# *SILVER BOW CREEK INVESTIGATION*

RESPONSES TO COMMENTS RECEIVED FROM  
ARCO COAL COMPANY ON THE WARM SPRINGS  
PONDS PHASE II REMEDIAL INVESTIGATION  
DATA SUMMARY REPORT

CH2M HILL, Inc.  
Helena, Montana

December, 1990

**FIGURE 2-13** AVERAGE ZINC CONCENTRATIONS; SS-19 TO PS-12  
SILVER BOW CREEK CERCLA; PHASE II REMEDIAL INVESTIGATION  
SEPT., 1987

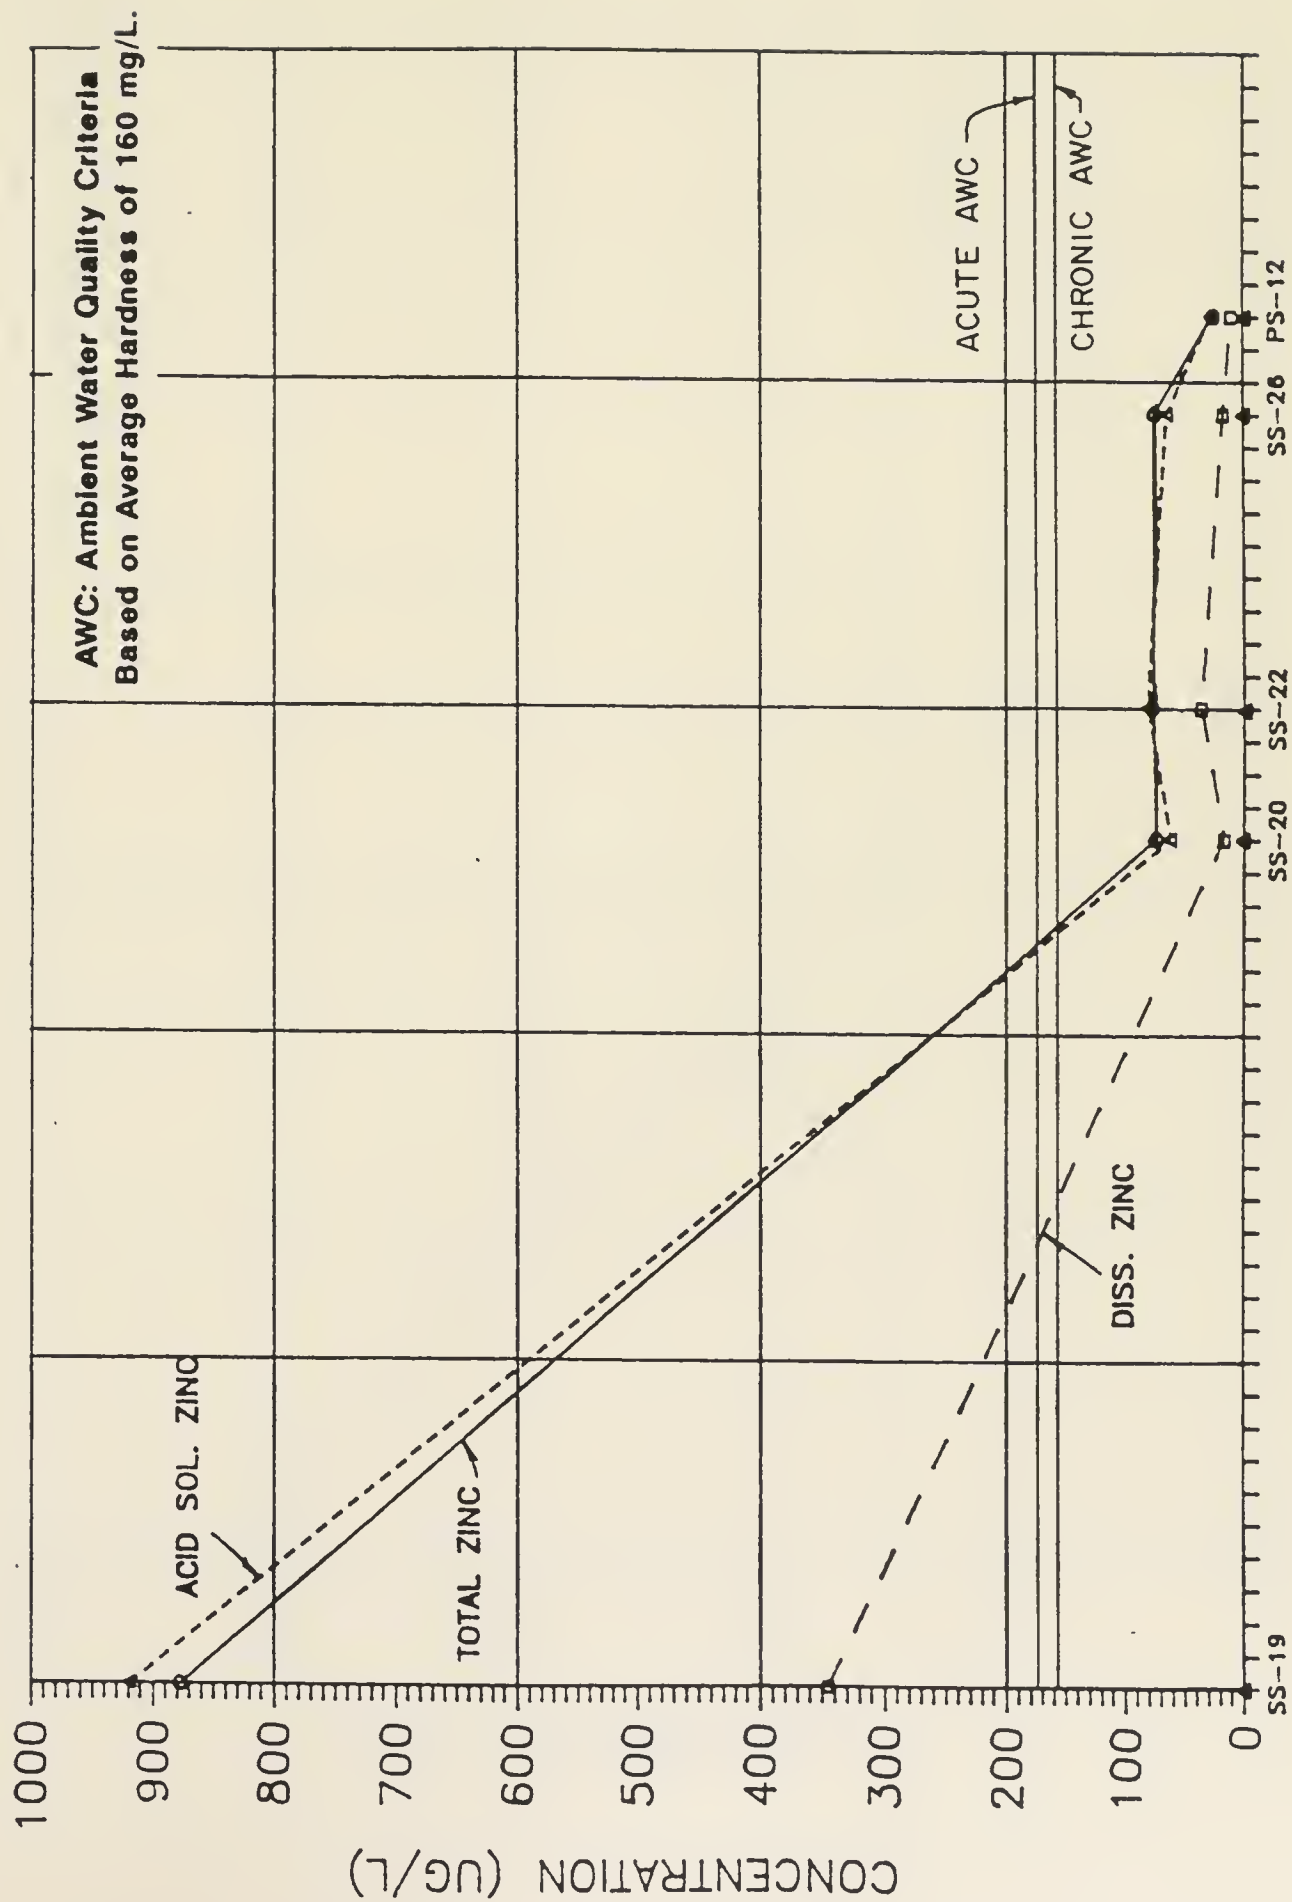
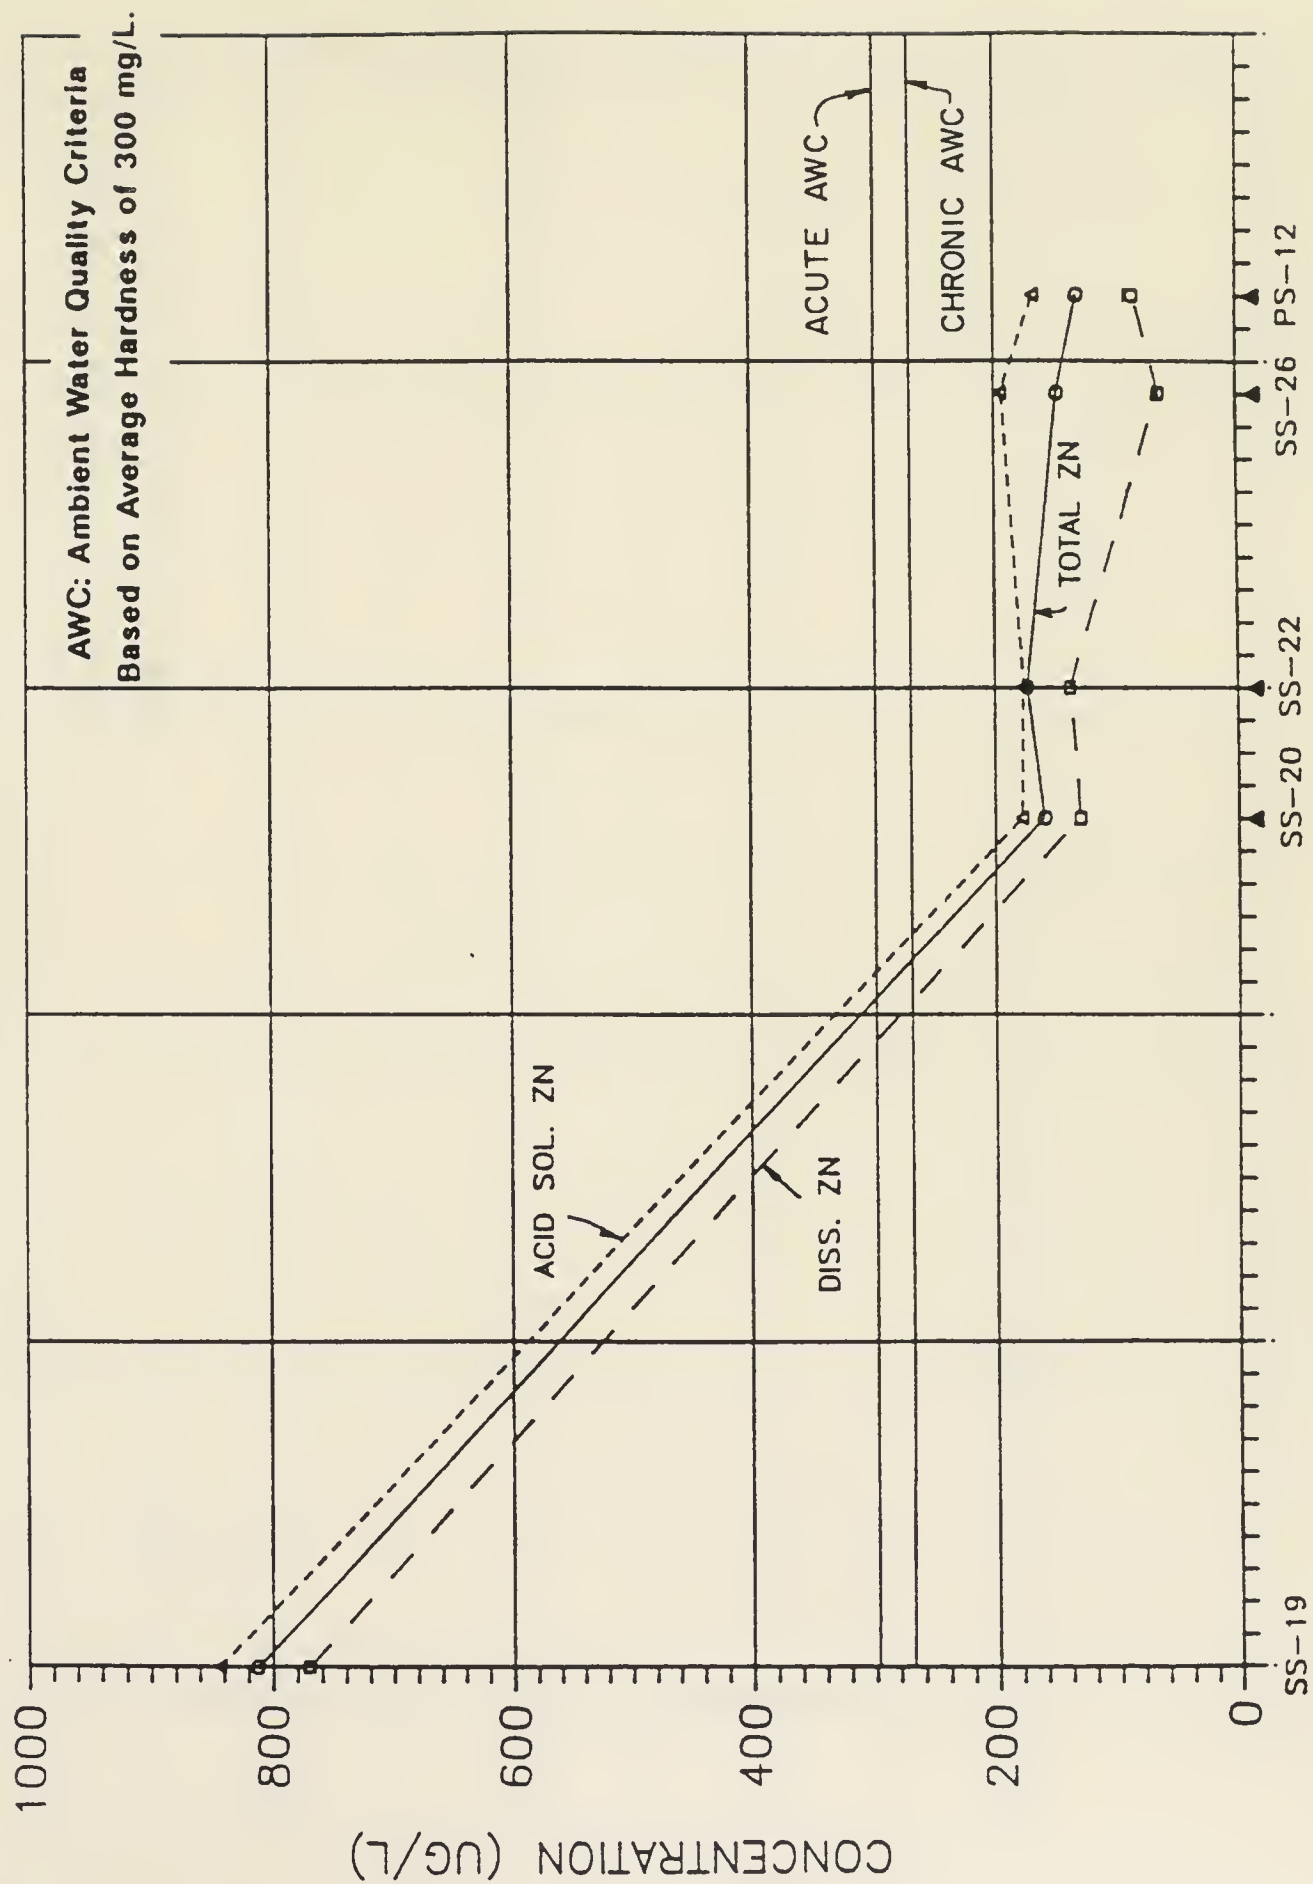
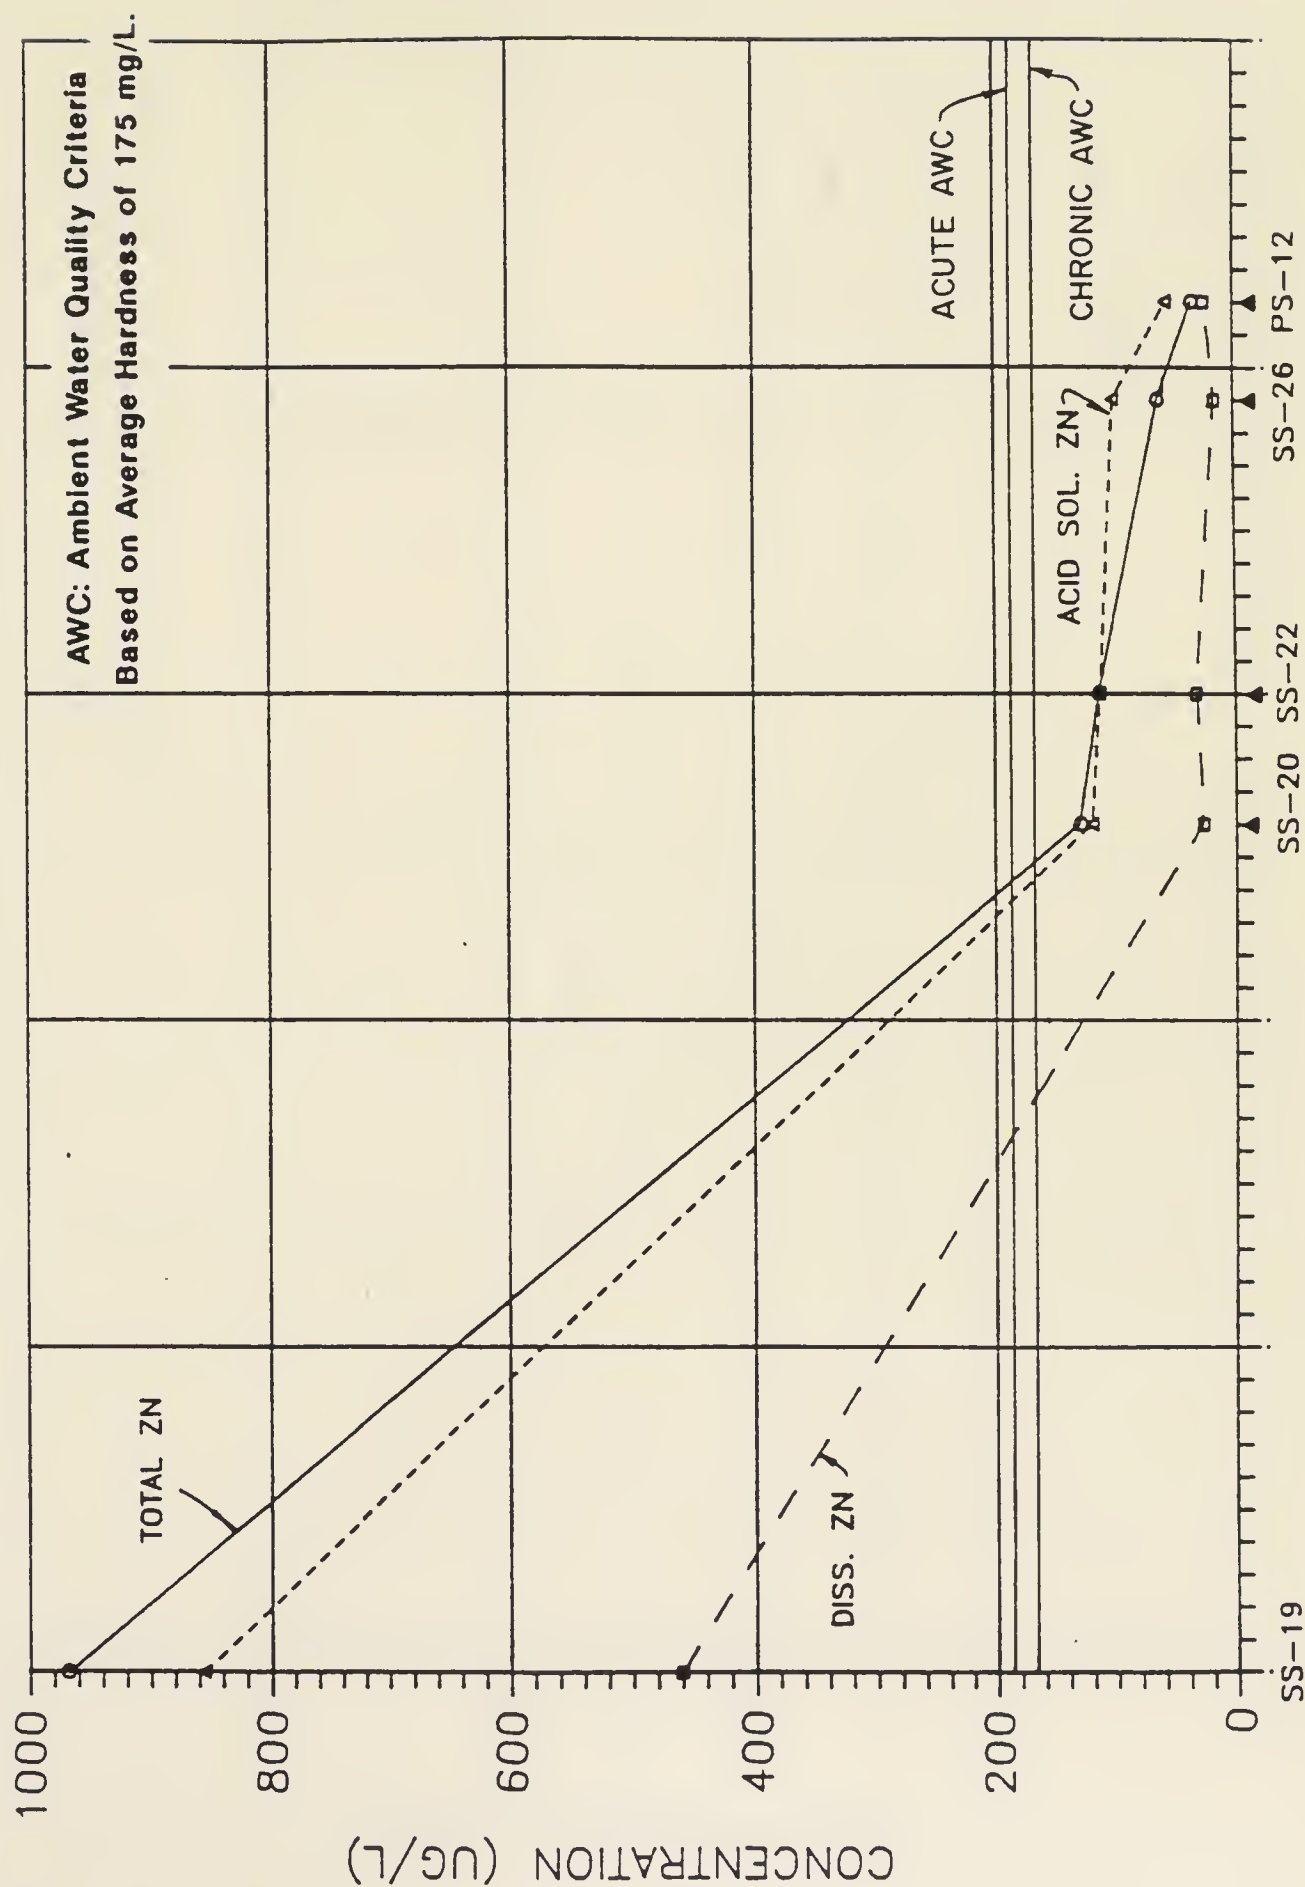
15. *Values for the zinc ambient water quality criterion (i.e. Gold Book) shown in Figures 2-13, 2-14, 2-15, 2-18, and 2-19 are incorrect and should be corrected. These figures all shown chronic AWC values below 100 ug/L. Based on a minimum hardness of 160 mg/l as CaCO<sub>3</sub>, the acute concentration criterion for zinc should be at least 157 ug/L (52 Federal Register 6213, May 2, 1987). As a result, Table 2-4 is also incorrect and should be revised to reflect the correct water quality criterion. This will alter the number of samples exceeding the water quality criteria. The table should also list the actual numerical values being used for water quality criteria.*

Response: Values for the zinc ambient water quality criteria illustrated on Figures 2-13, 2-14, 2-15, 2-18, and 2-19 are incorrect. The correct values for these criteria include the following:

Figures 2-13, 2-14, 2-15, 2-18, and 2-19 have been revised and are included as Attachment A to this response document.
